February 28, 2022

On behalf of the Board of Directors of Metro West Collaborative Development I am writing to request the Zoning Board of Appeals' consideration of a modifications to our Comprehensive Permit for the development of Glen Brook Way on West Street. We believe this constitutes an insubstantial modification and we ask that the Board determine that it is insubstantial.

Glen Brook Way Phase 2
	Parking Lot/Pedestrian Light, Typ. 2 L400	Glen Brook Way Medway, MA 02053
	Bituminous Concrete Parking Area, (See Civil Dwgs.)	
	Concrete Sidewalk (Typ.) See Sheet L200 for Score Joint Layout. (See Civil Dwgs and Specs for typical installation detail and materials.)	Meander Studio Collaborative Design
ž	Generator Pad, See Electrical Dwgs.	
	Transformer with Bollards, See Electrical Dwgs.	
	Gas Grill, powered by gas canister, provided by Owner Maintenance Shed on Concrete Pad	CBA Landscape Architects LLC
	ADA—compliant 3—seat Table 1 with Metal Umbrella (Qty:1 at 400 Plaza E)	phone 617.945.9760 I www.cbaland.com I cba@cbaland.com landscape architecture urban design master planning
Low	<u>6-seat Tables with Metal</u> Umbrellas (Qty: 2 at Plaza E)	
	Concrete Paving, See Sheet L200 for

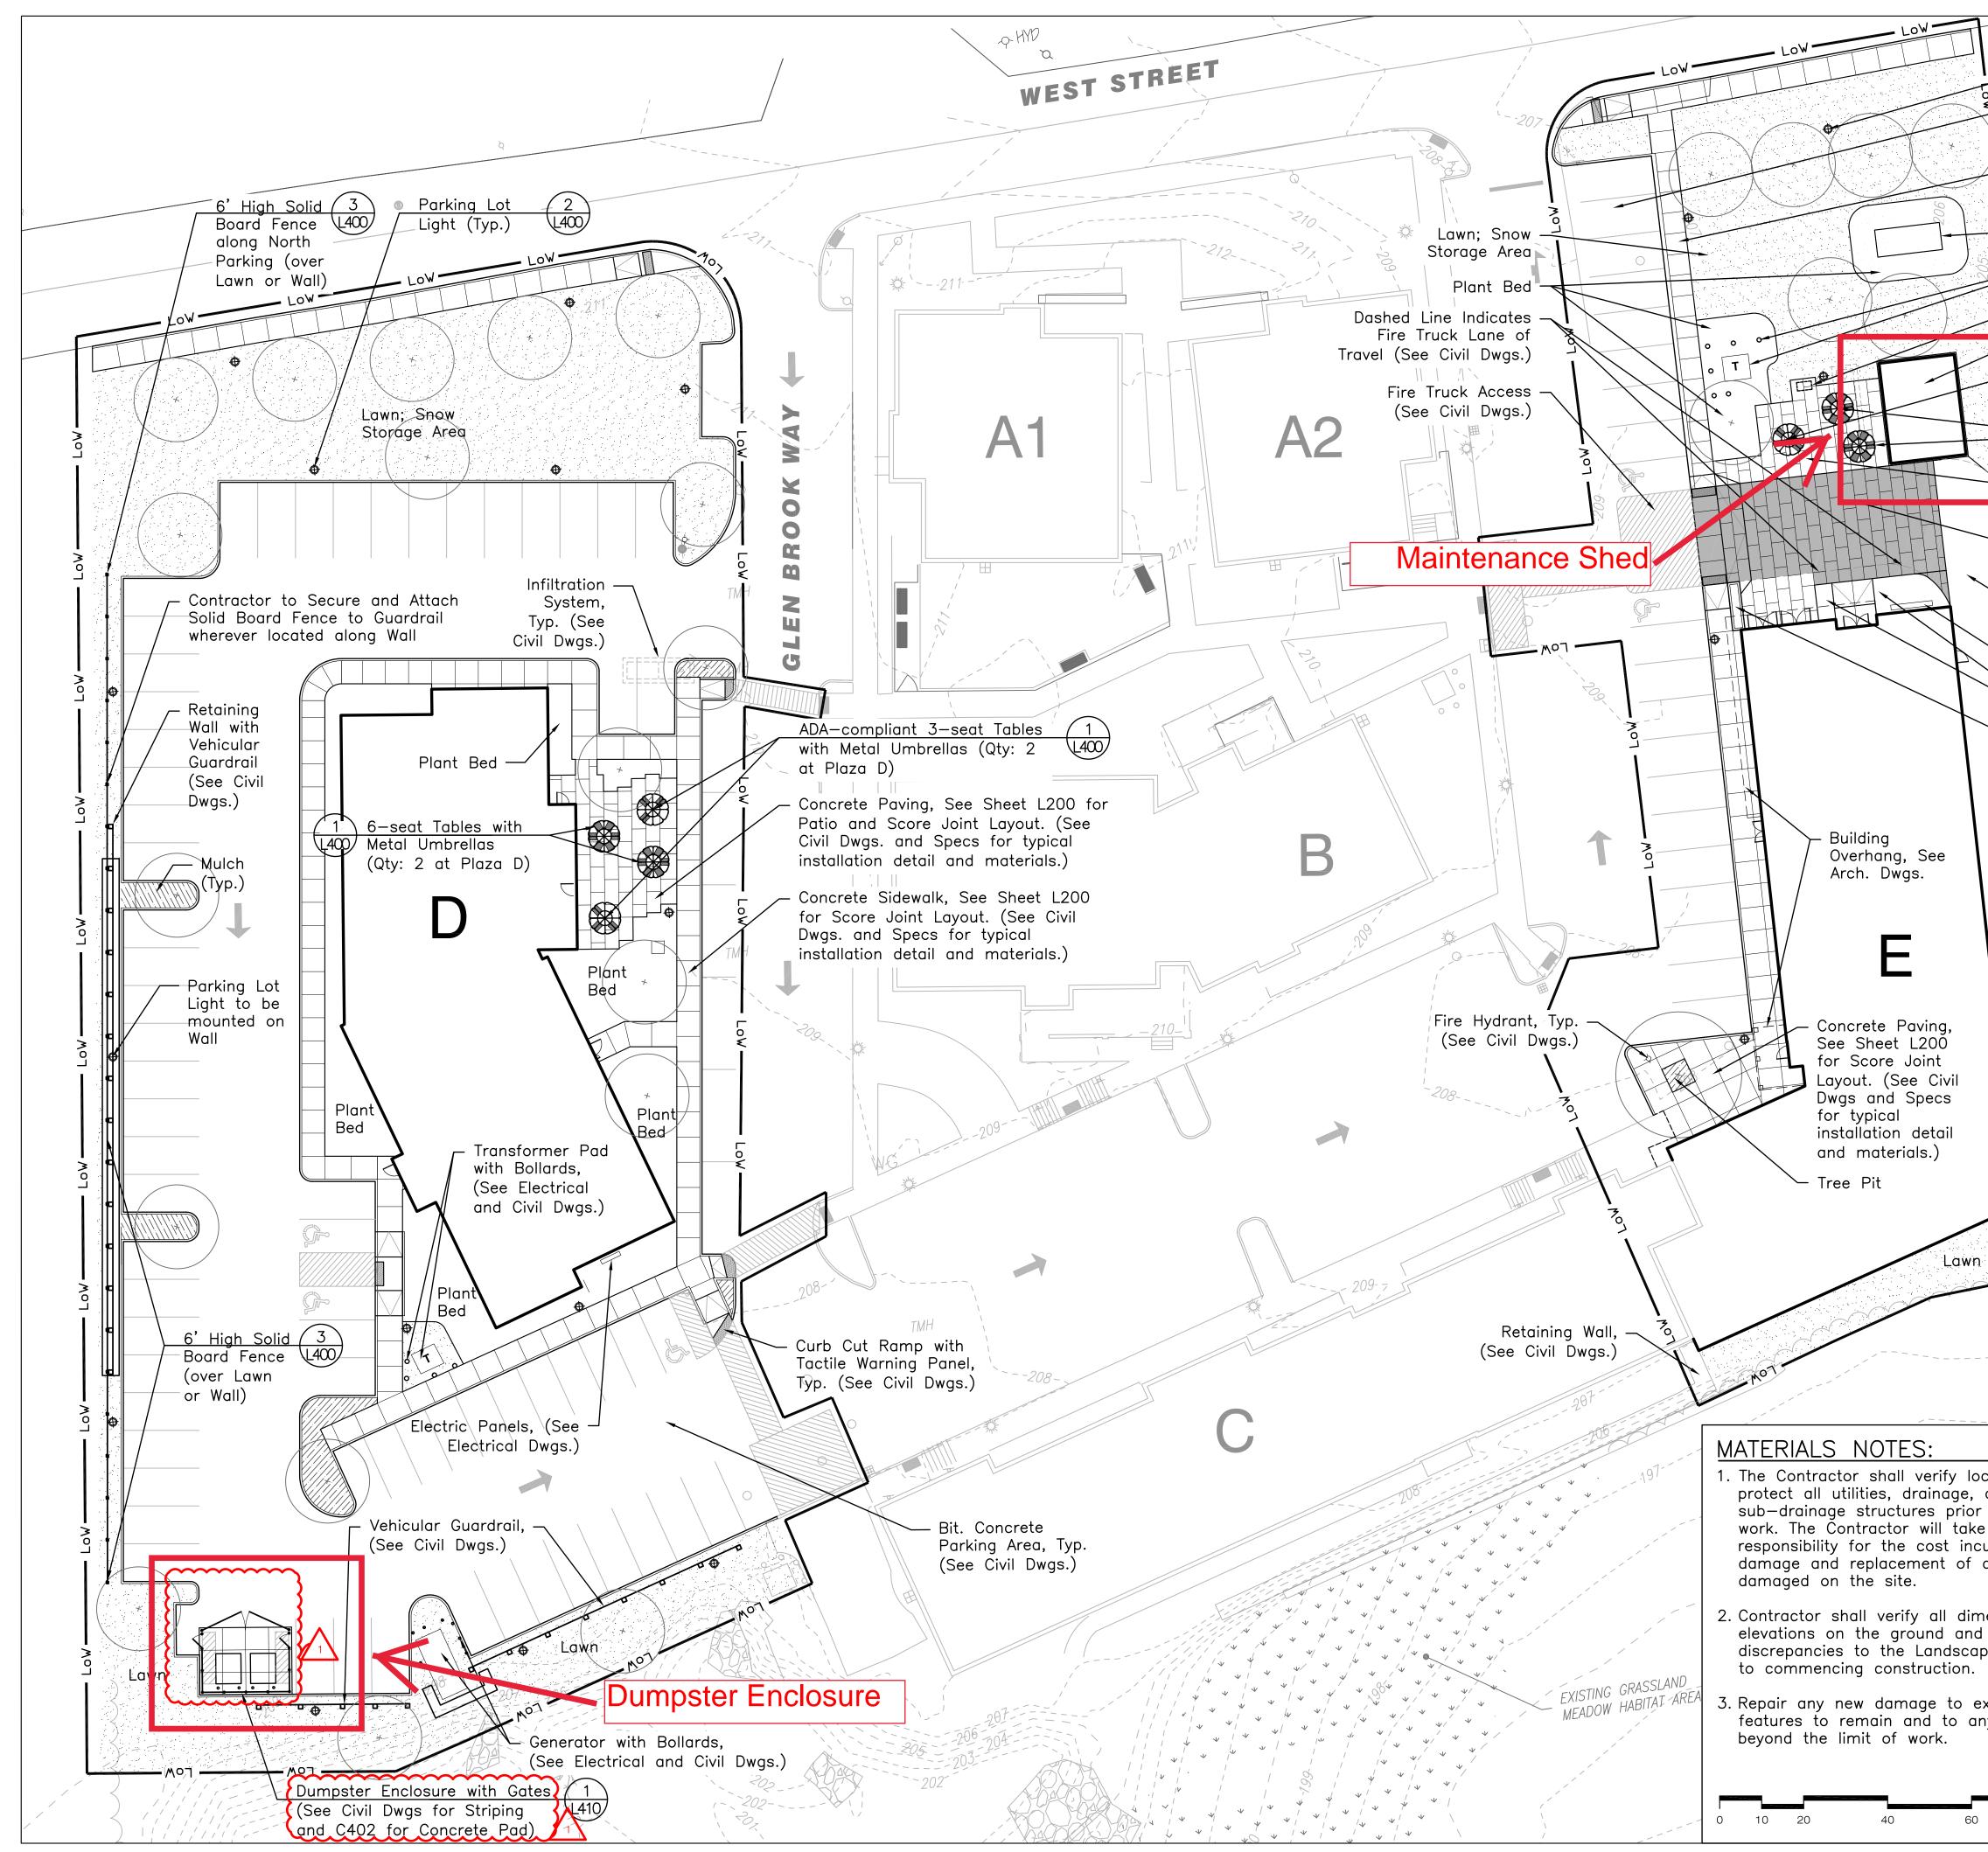
1) We request permission to build a Dumpster Enclosure and Maintenance Shed during Phase II at the locations indicated on the attached drawing. These ancillary structures will aid in the efficient operation of the property.
